October 12, 2017

**Additional Information Submittal
Hydrogeological Re-Evaluation
Aughwick Creek Horizontal Directional Drill (S2-0153)
Application No. E31-234
Shirley Township, Huntingdon County**

ATTACHMENT 1
HORIZONTAL DIRECTIONAL DRILL PLAN AND PROFILES

Revised 20-Inch HDD Plan and Profile

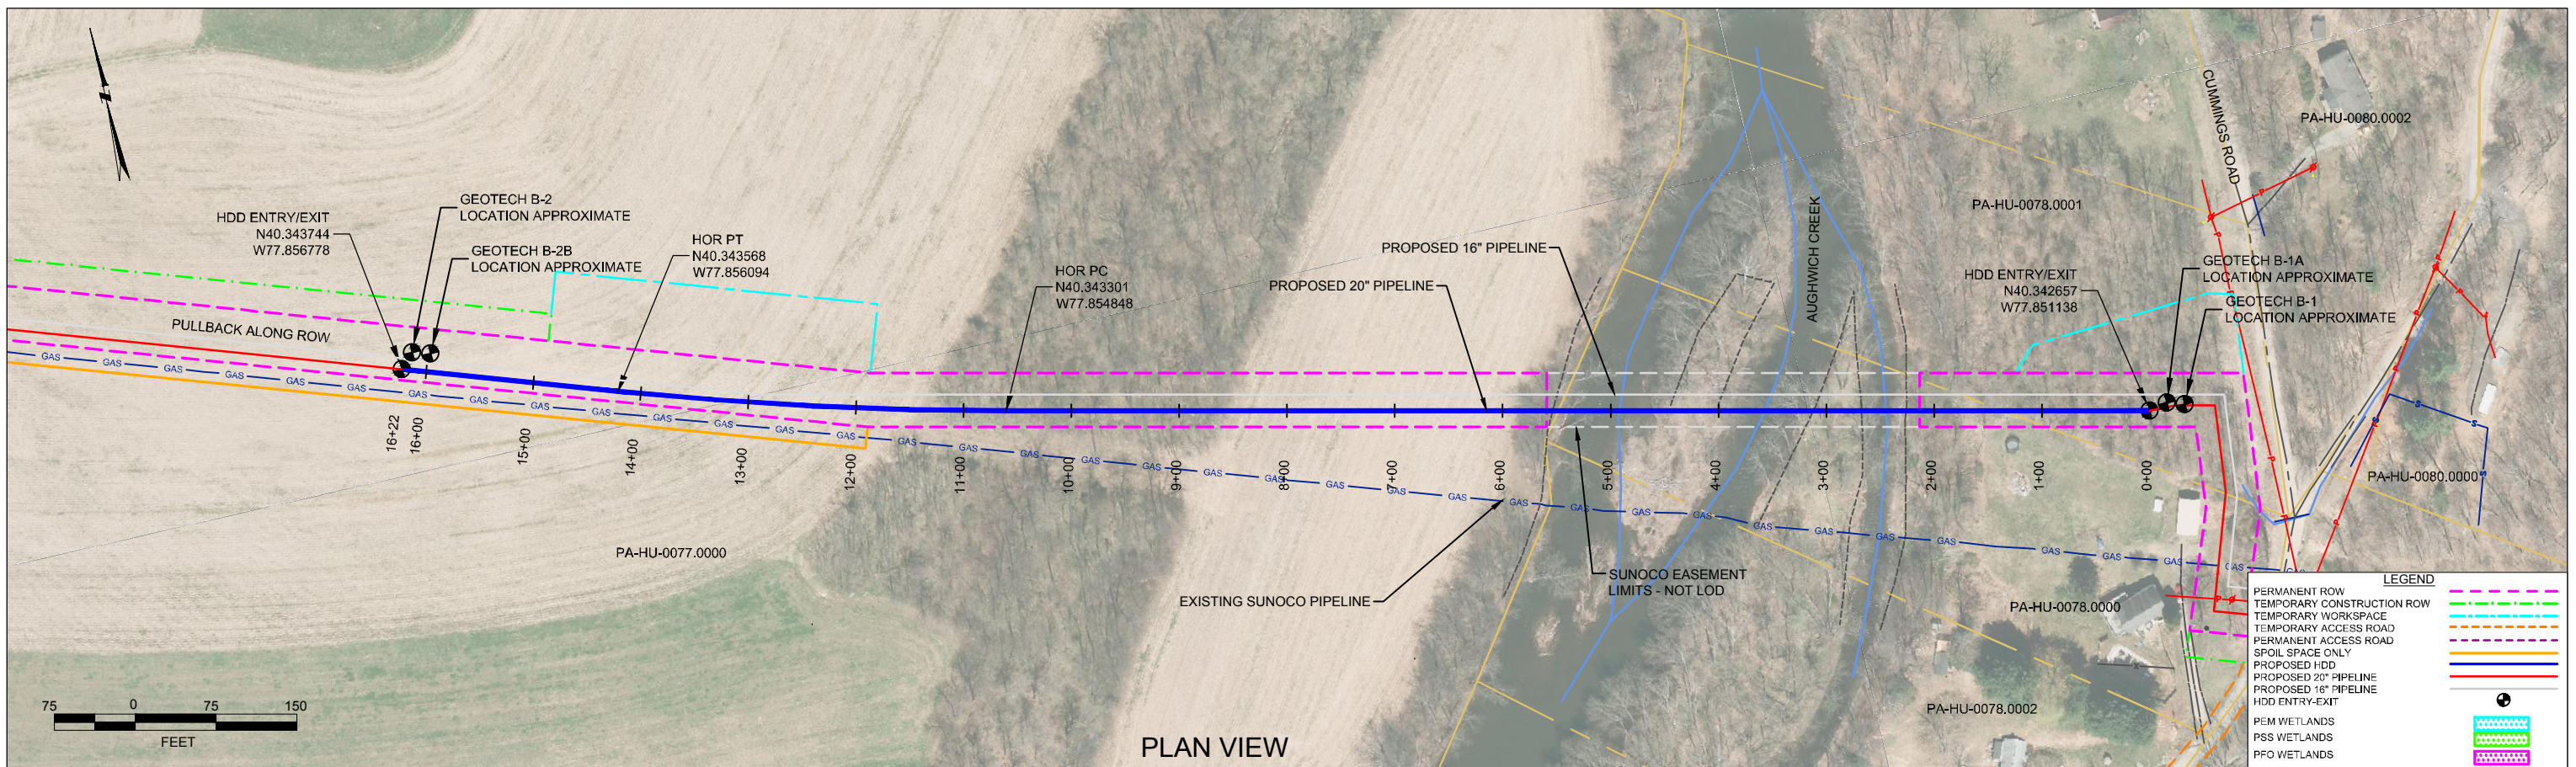
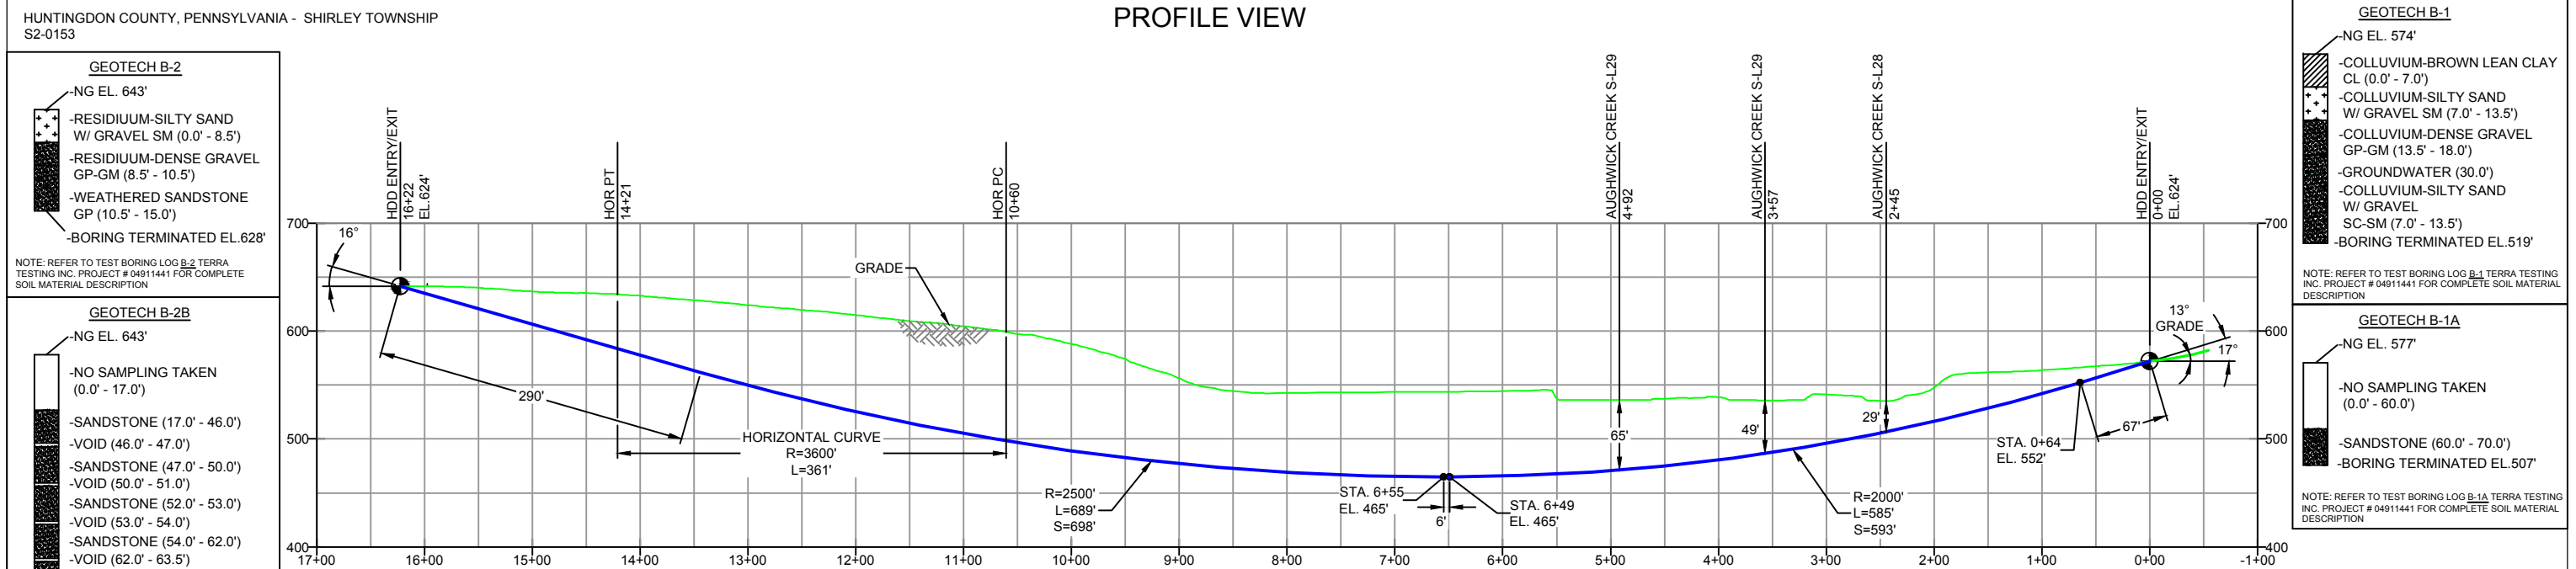
1. *No cross-sections or profiles of the HDD were provided.*

After further study by the drilling contractor and SPLP HDD specialists the HDD profiles for the crossing of Aughwick Creek have been revised. Copies of the revised profiles are included with this response as Attachment 1.

As noted on these profiles, the angle of entry on the east side of the HDD, which will be the drilling rig setup and entry side has been increased to 17 degrees for both HDDs. The increased angle of entry will sharpen the rate of descent to horizontal depth following the allowable pipe curvature radius. As a result the new 20-inch depth of crossing under the first channel of Aughwick Creek will be 29 ft (versus 18 ft), 49 ft (versus 32 ft) under the second channel, and 65 ft (versus 40) under the third channel. The 16-inch channel crossing depths are 32 ft, 55 ft, and 73 ft respectively.
